Retreat at TimberRidge

PRELIMINARY PLAN

EL PASO COUNTY, COLORADO

SP 182

BUILDING CONSTRAINTS MAP

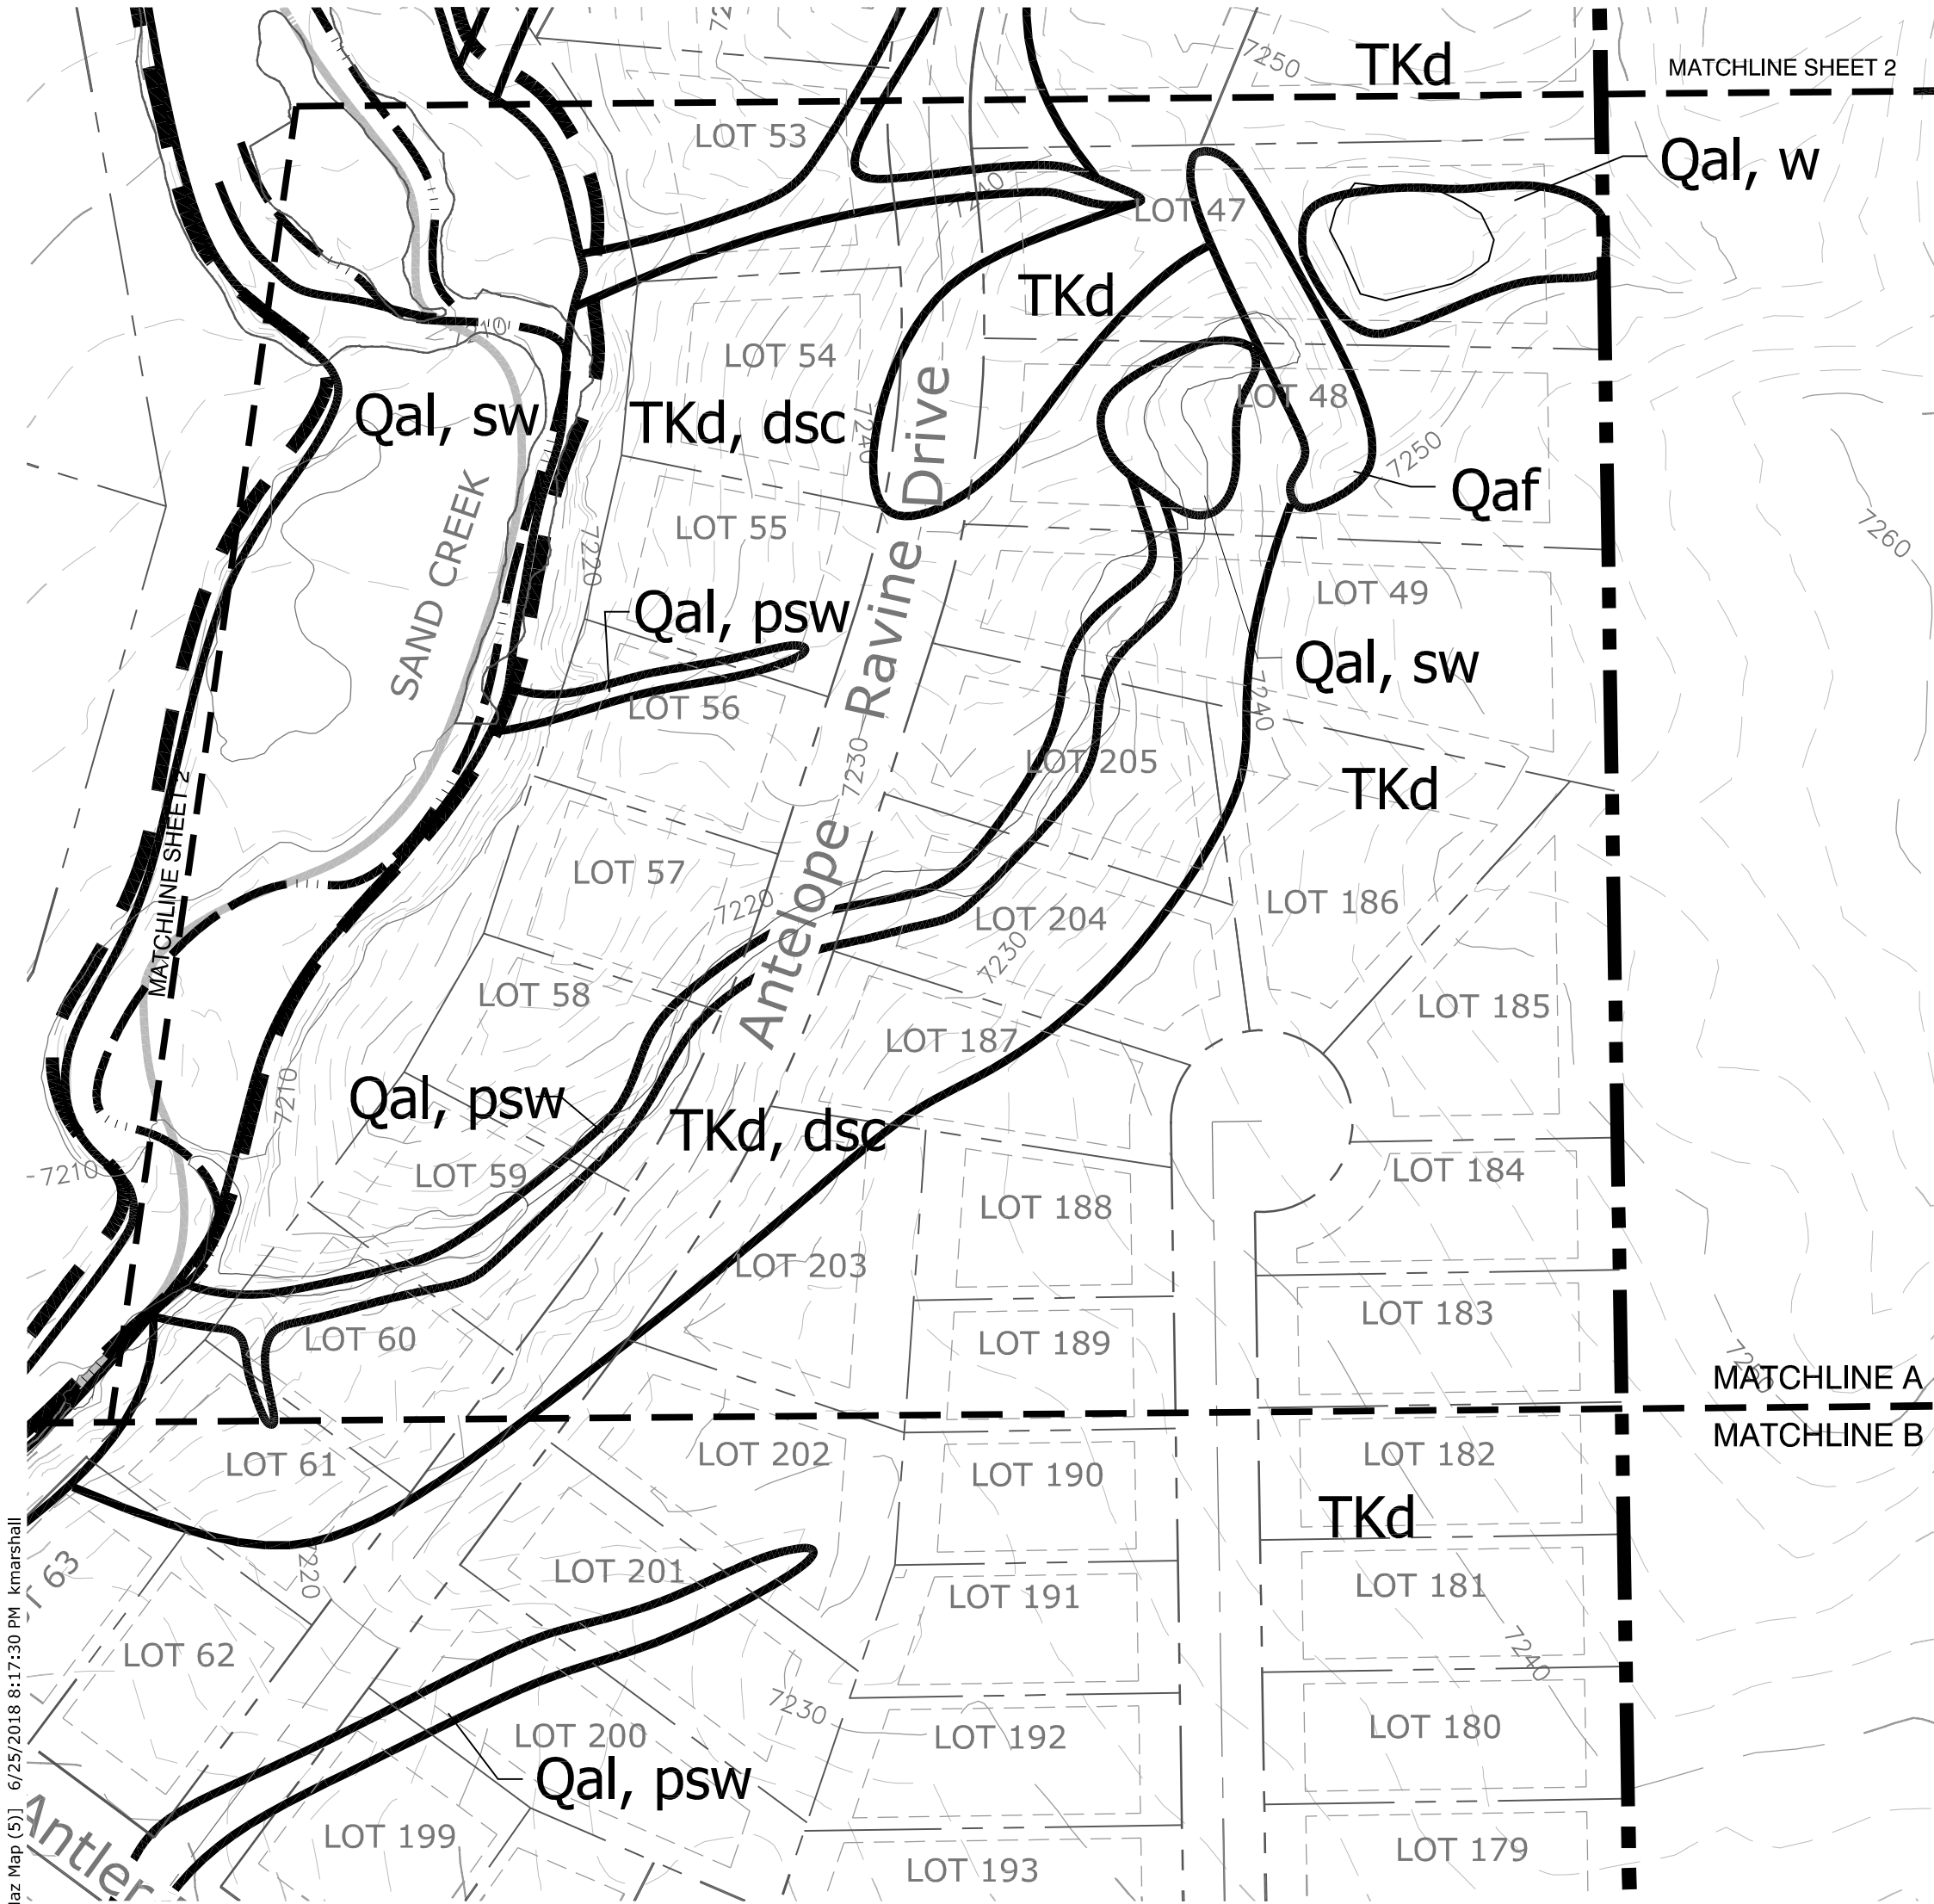
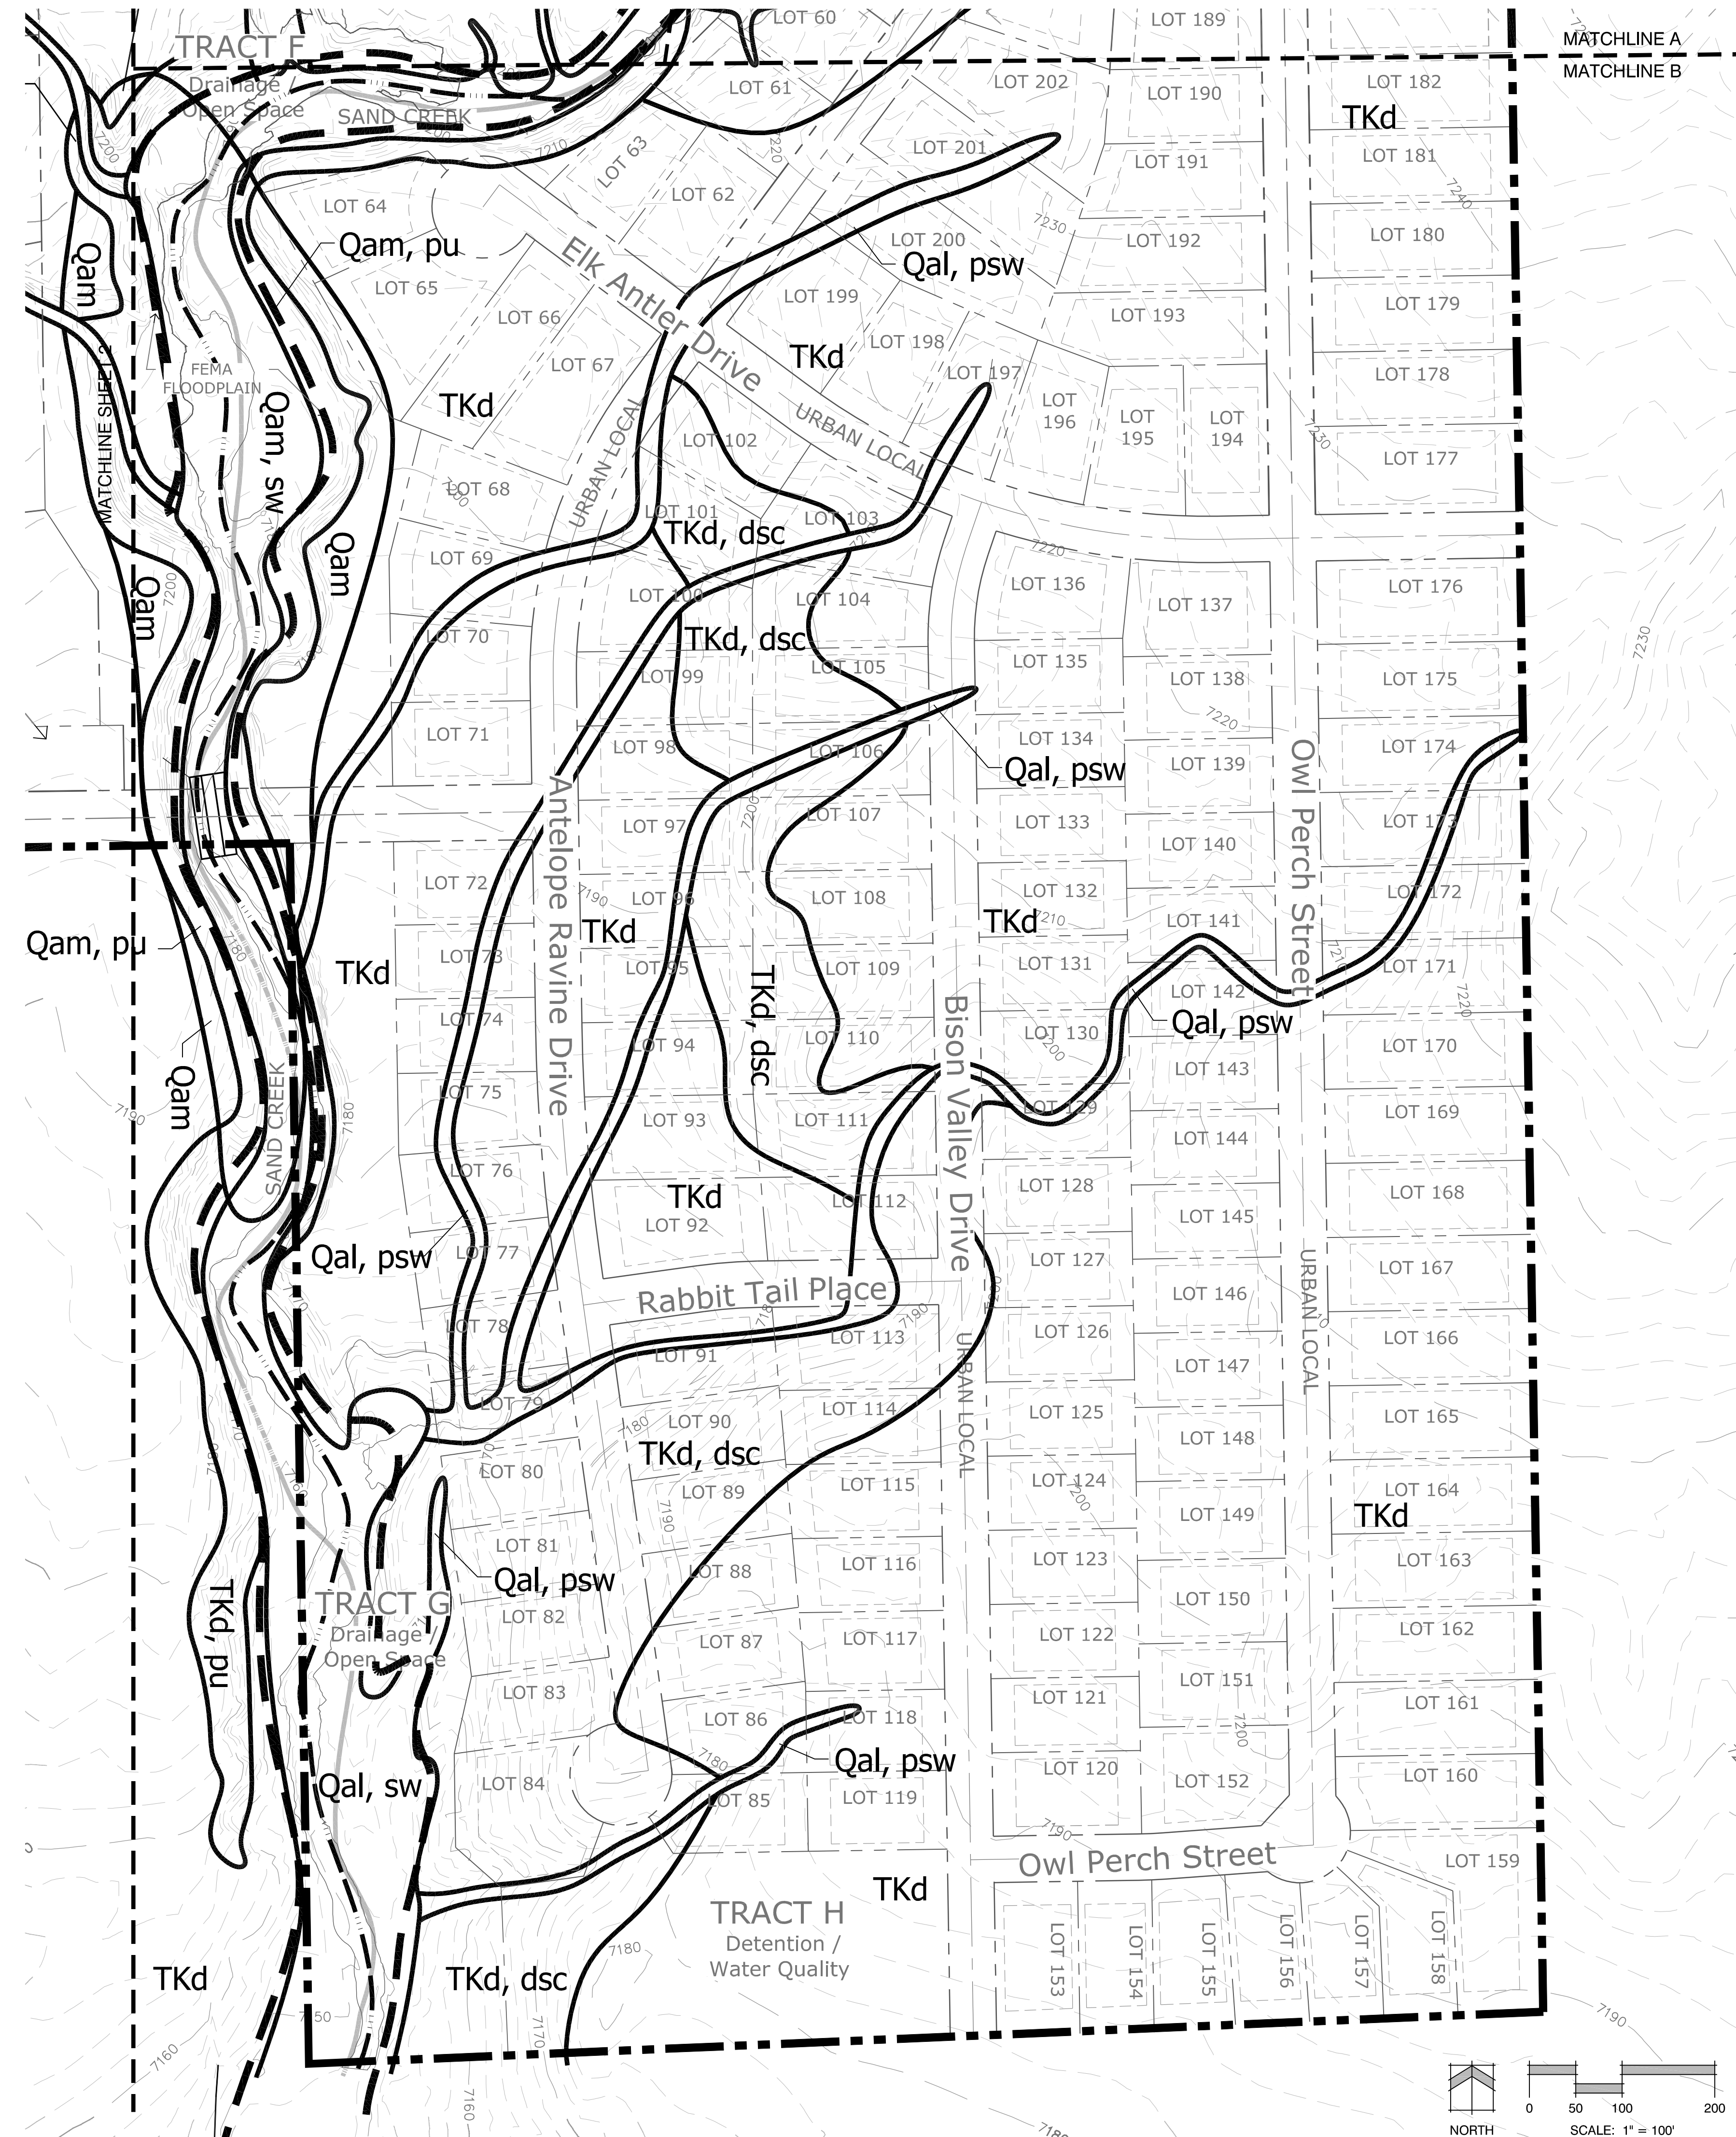
Identify the wetlands and areas in lots that are to be preserved by no-build areas- all sheets where impacted OR identify no build areas on Constraints Map (sheets 4 and 5)

S2 RURAL LOCAL ROAD TYPICAL SECTION - 60' ROW
SCALE: 1" = 1'-0"

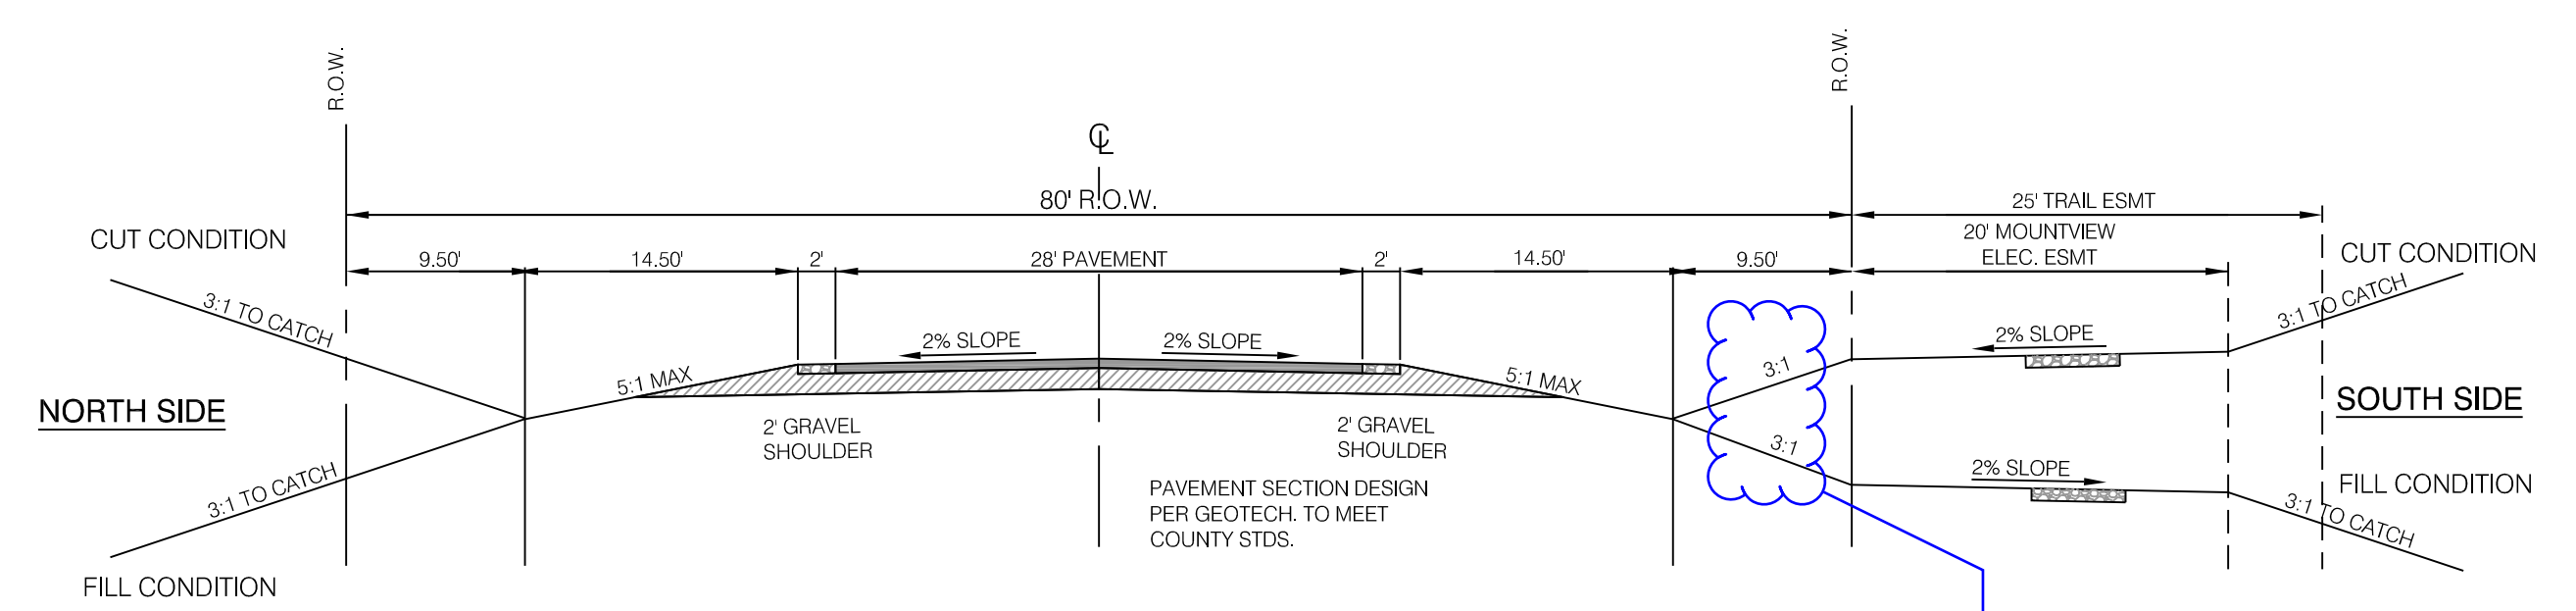
To be determined/ adjusted with construction drawings so that the trail will not need to be relocated with future road widening.
